Agenda Item #4

Certified Record 2025-47-CA

360 Dauphin Street

Alterations to south facade

A3

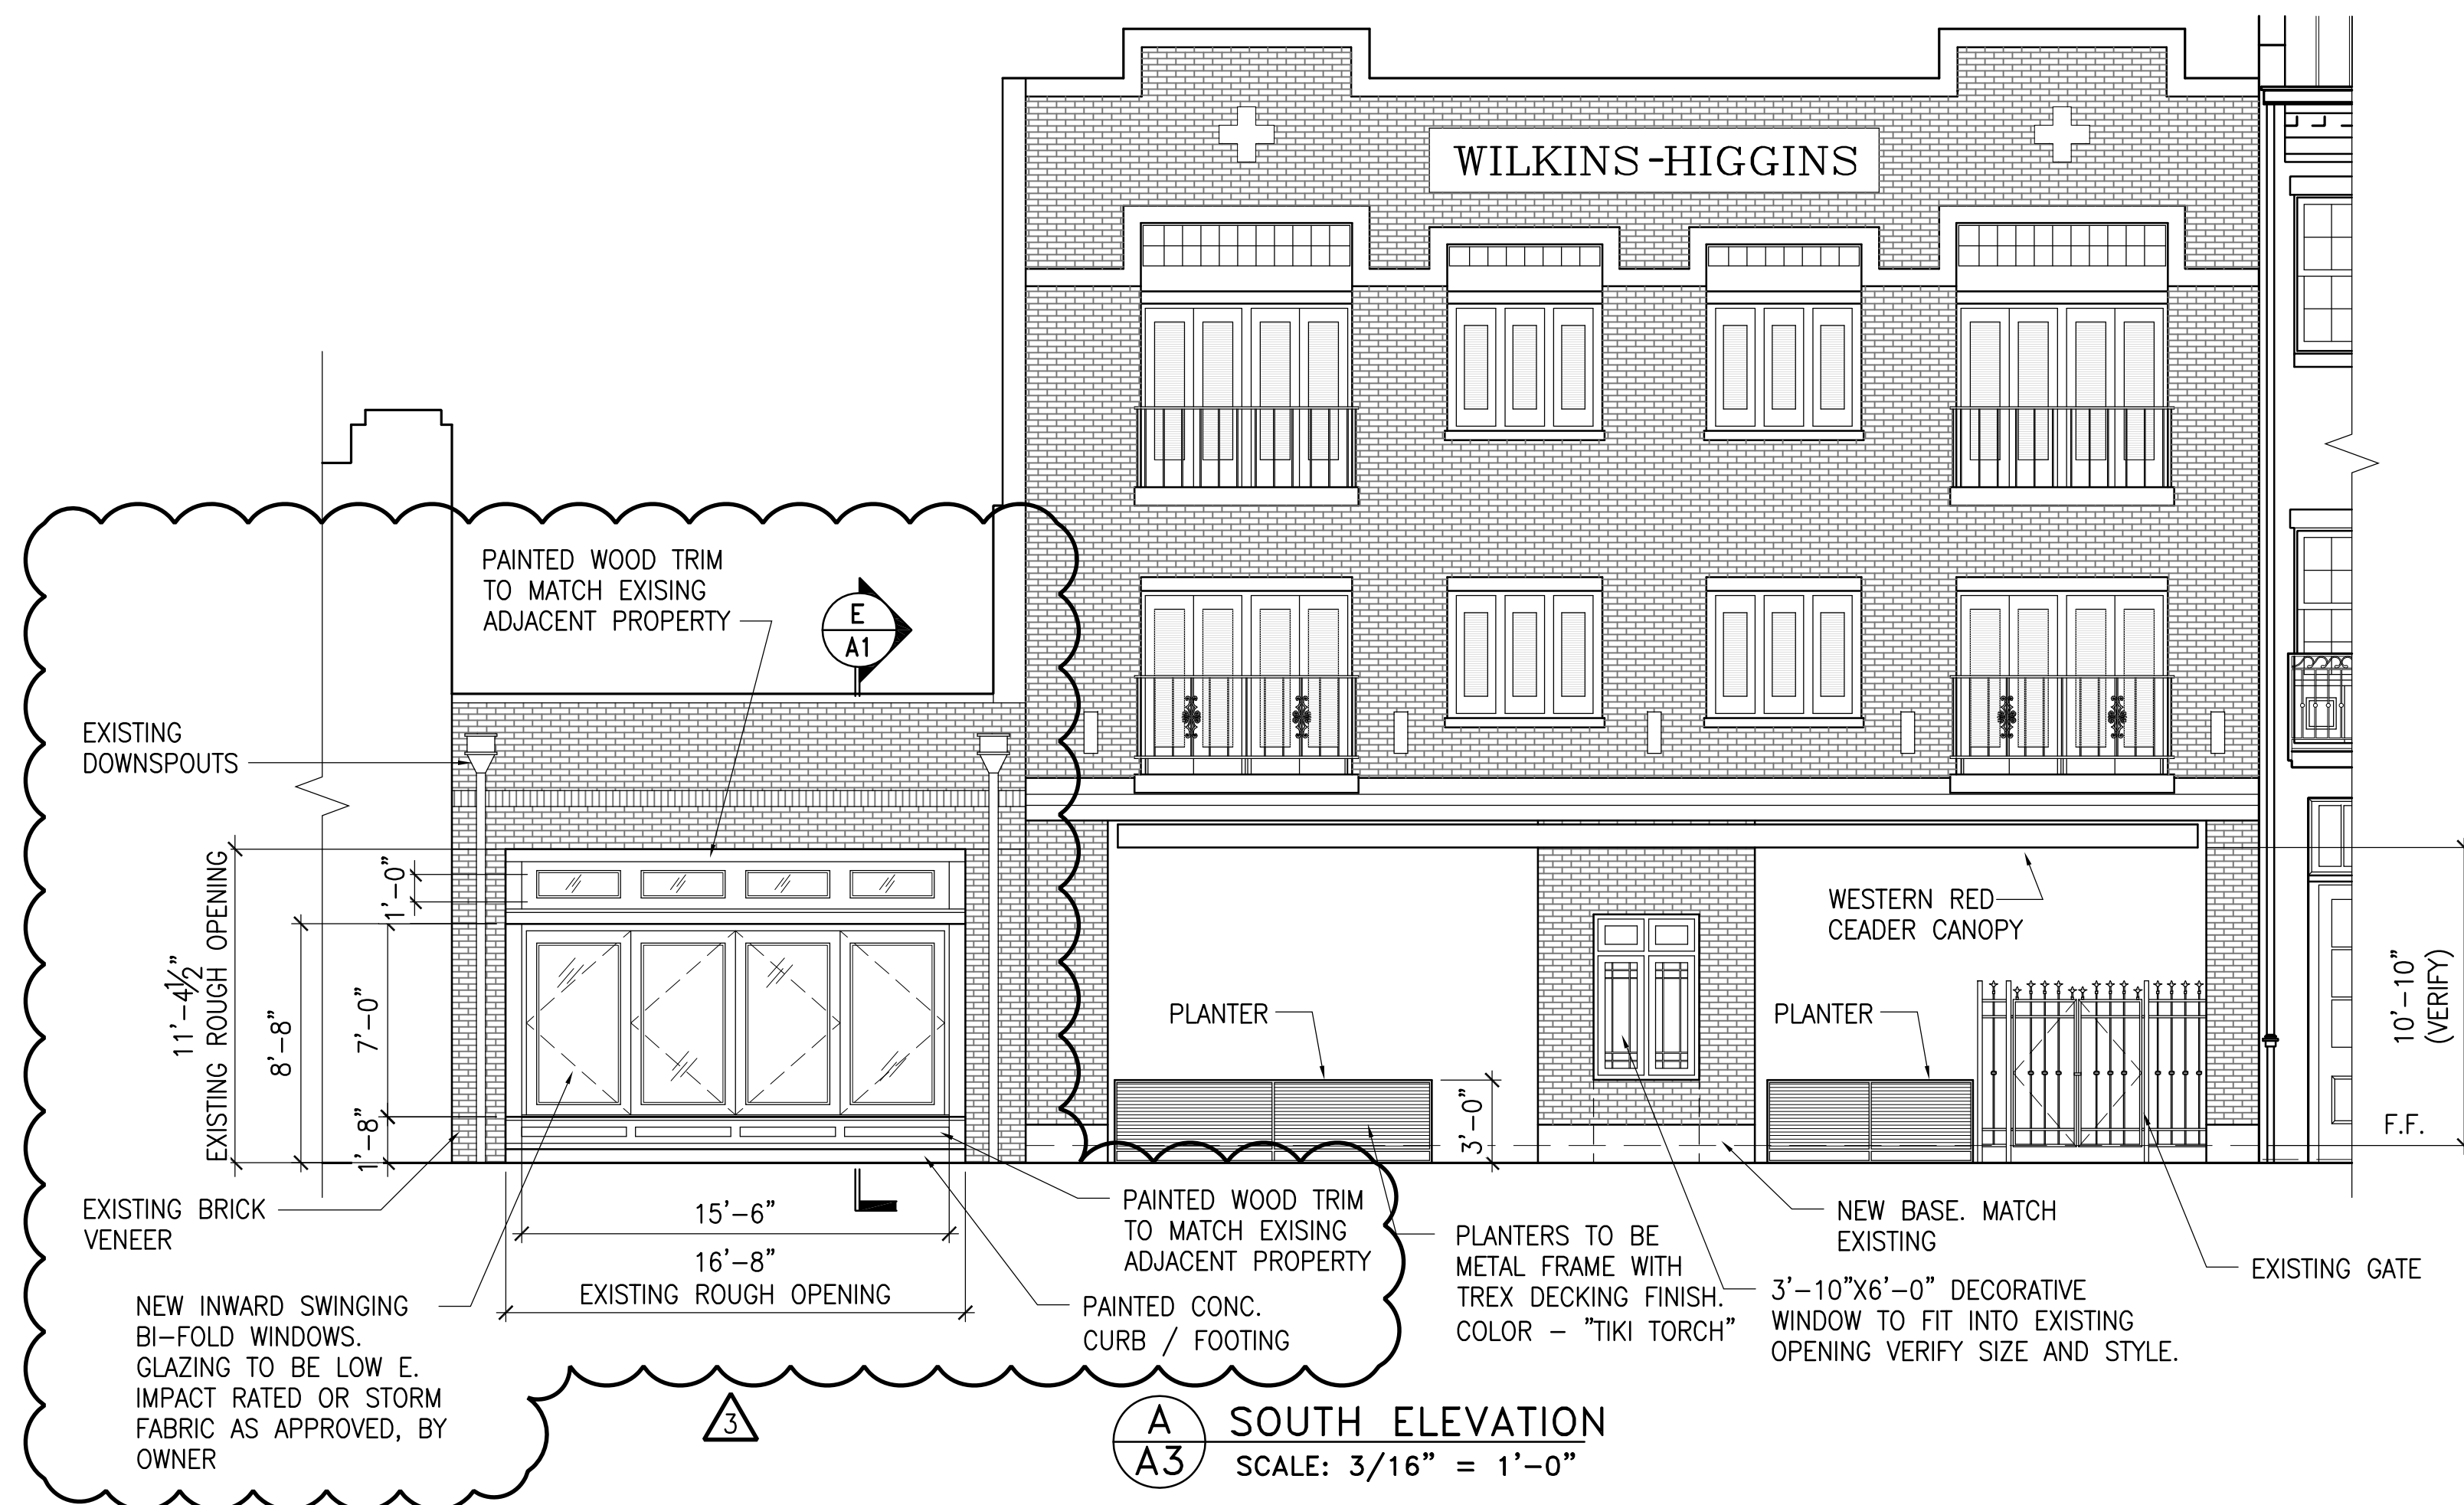
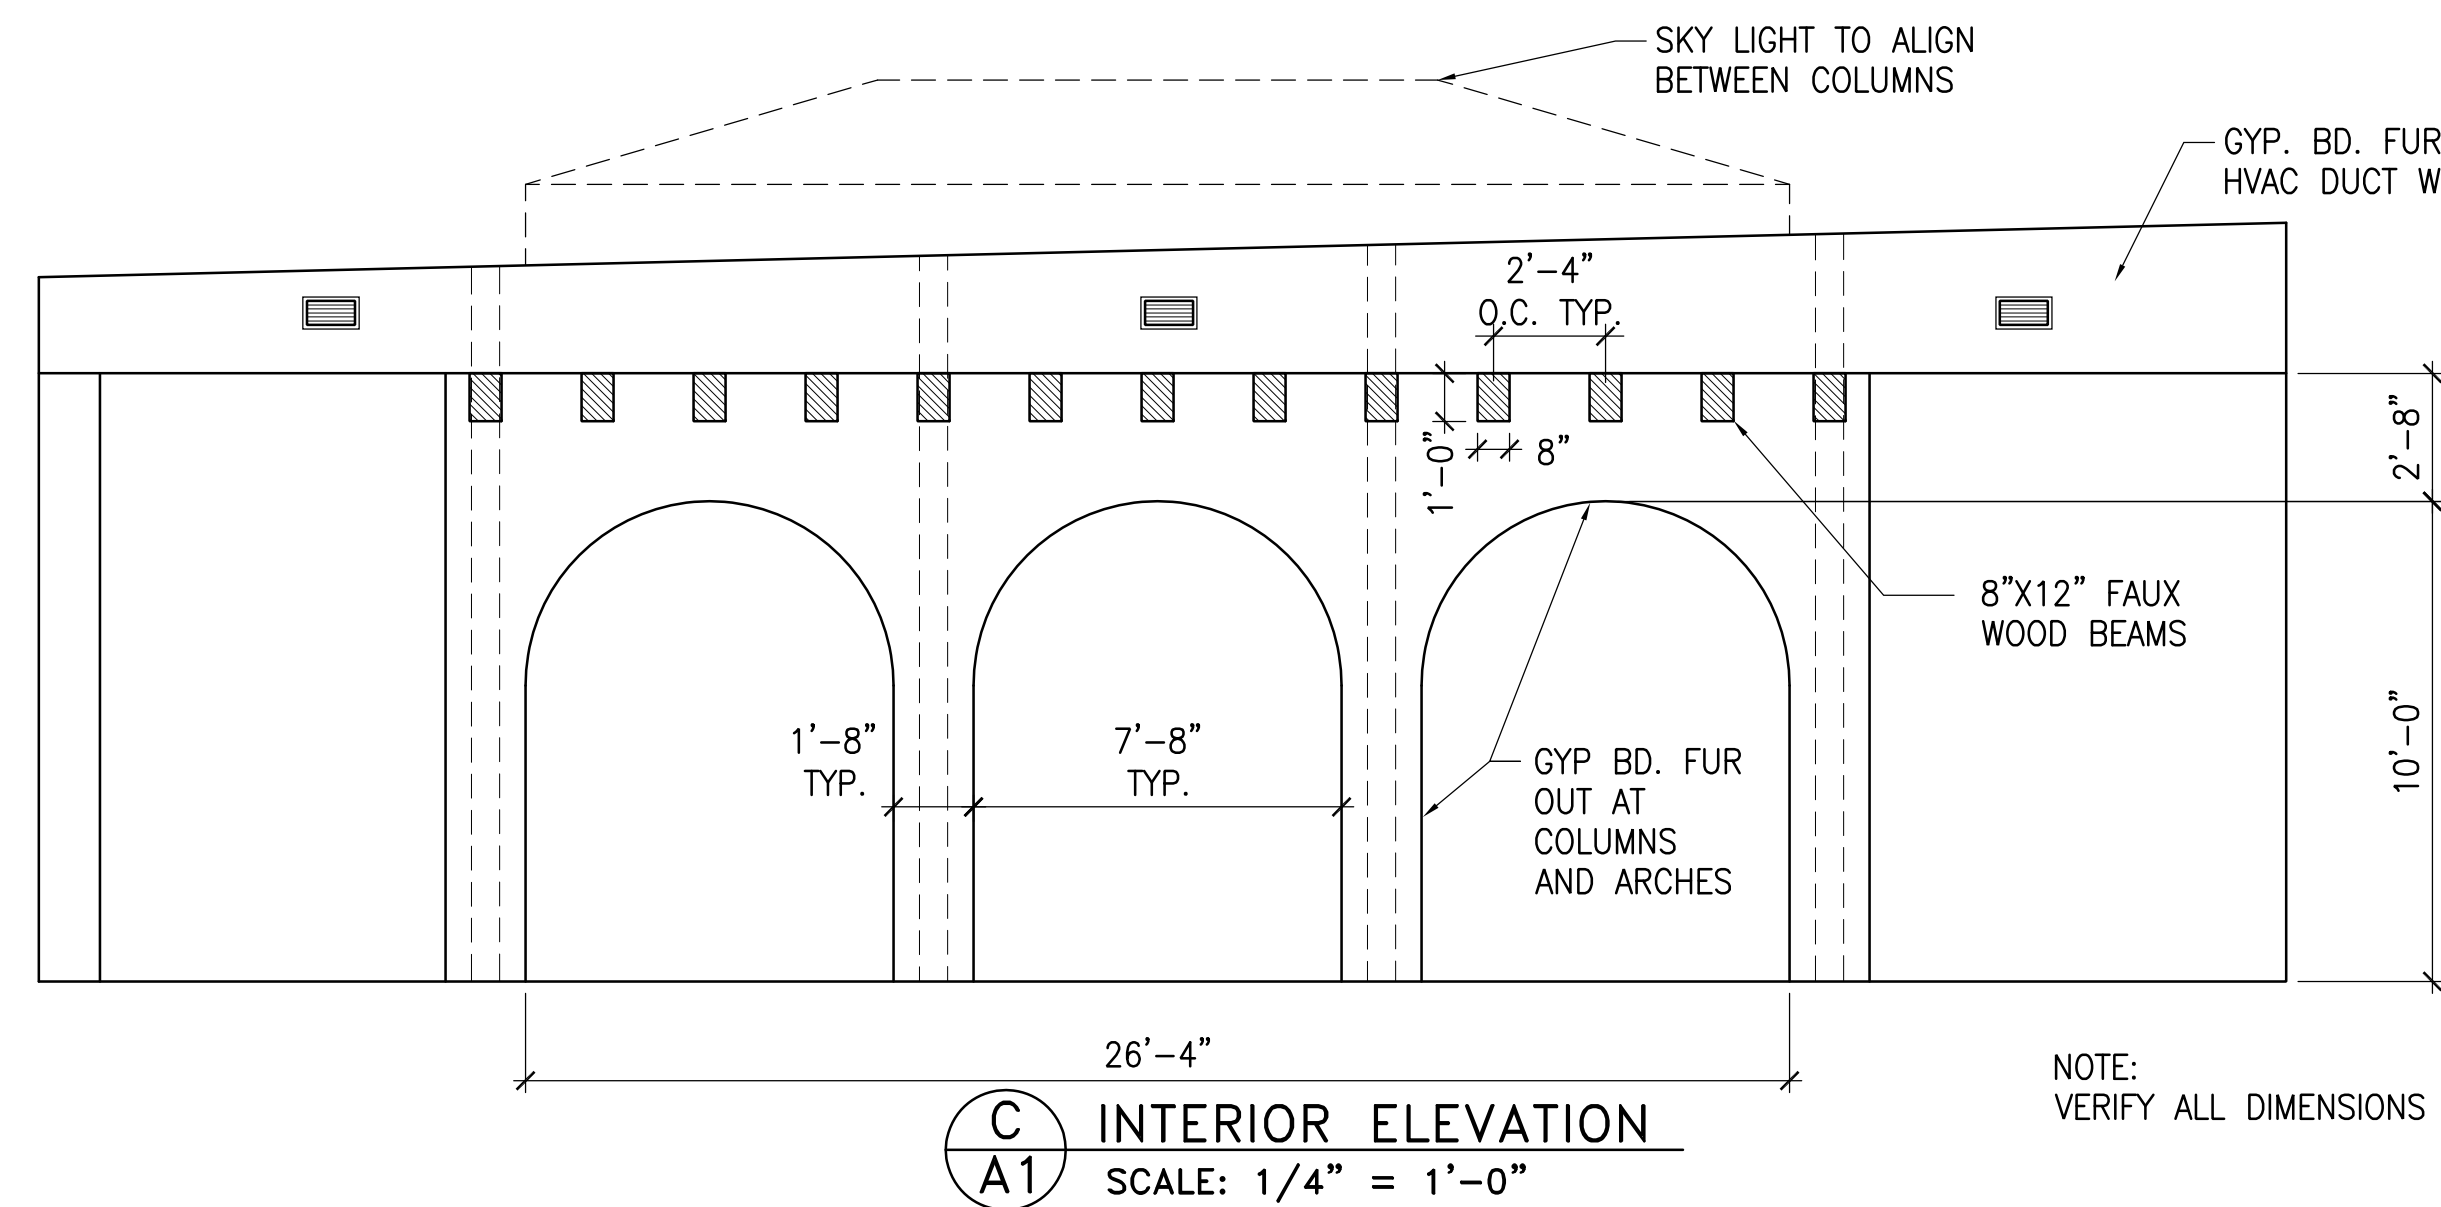
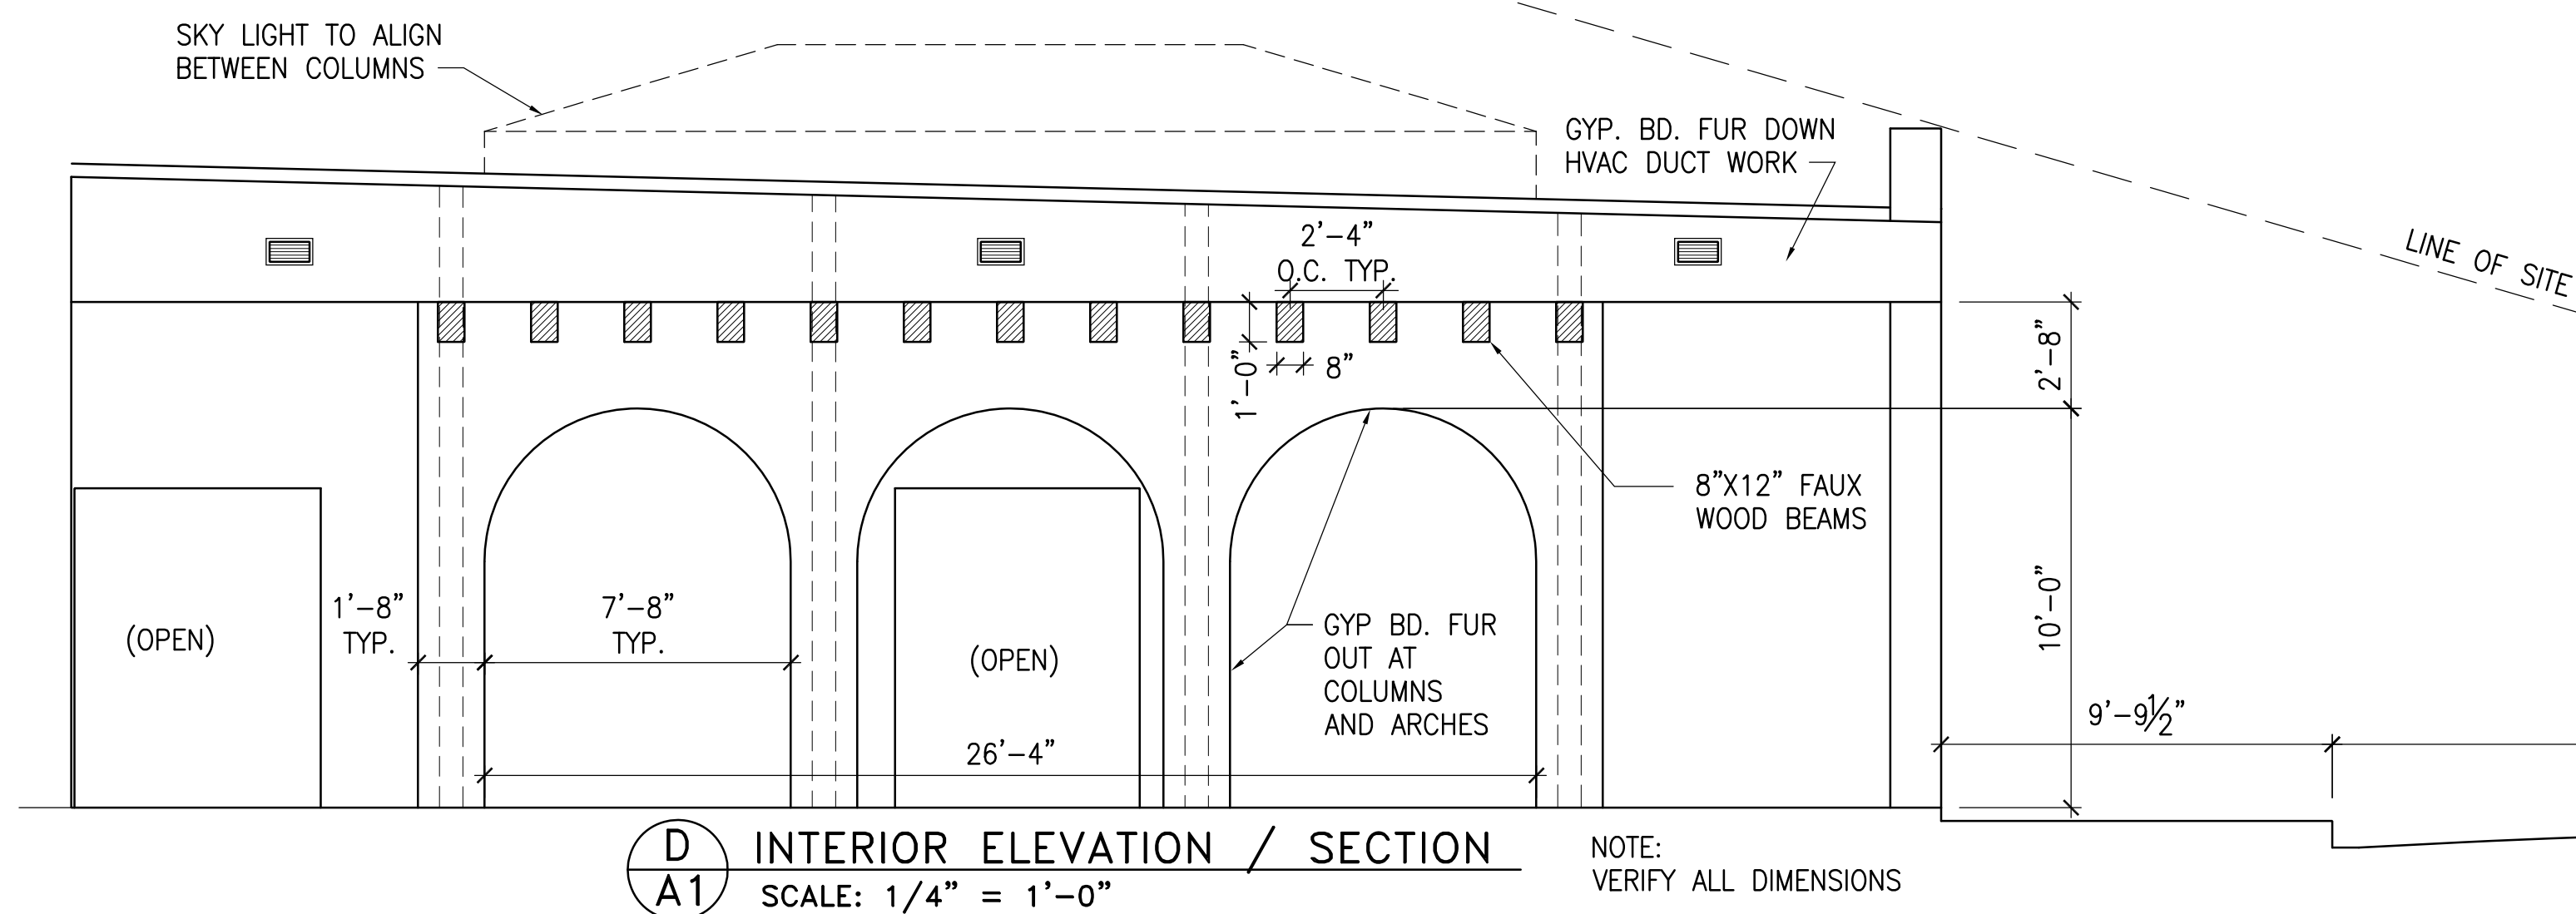
There is no storefront extant on the facade in question, and photographic evidence is insufficient for replicating the form, orientation, or details of an original or historic storefront in this location. Photographic evidence shows that a chamfered recessed glass-and-aluminum storefront existed in 1981, but the storefront shown is clearly not original. The photograph shows that a transom window had been either painted over or boarded. The transom is flush with the facade, suggesting that an earlier storefront may have been flush rather than recessed. At least one panel of a semi-reflective cladding material has been removed or fallen away, revealing brick that appears to have been painted. In short, existing photographic evidence does not provide one specific original or historic design to emulate.

The proposed wood storefront and bank of windows with transoms will imitate the proportions and fenestration patterns of storefronts on adjacent buildings, especially at 362 Dauphin Street. The proposed design meets the Guidelines requirements in that it includes a bulkhead below the window, uses a high proportion of transparent glass, and uses replacement materials that are visually compatible with the original. The banded windows will emulate the proportions and transparency of a traditional storefront and, when open, will encourage interaction between the building interior and the public realm at least as much as a storefront entrance would have done. The aluminum windows are also visually compatible with the Wilkins-Higgins and other neighboring buildings. (7.3, 7.8, 7.18, 7.19)

The application also proposes installing a low-e film on the windows. The Guidelines discourage the use of opaque window treatments, so any applied window films should maintain an appropriate level of transparency. (7.19)
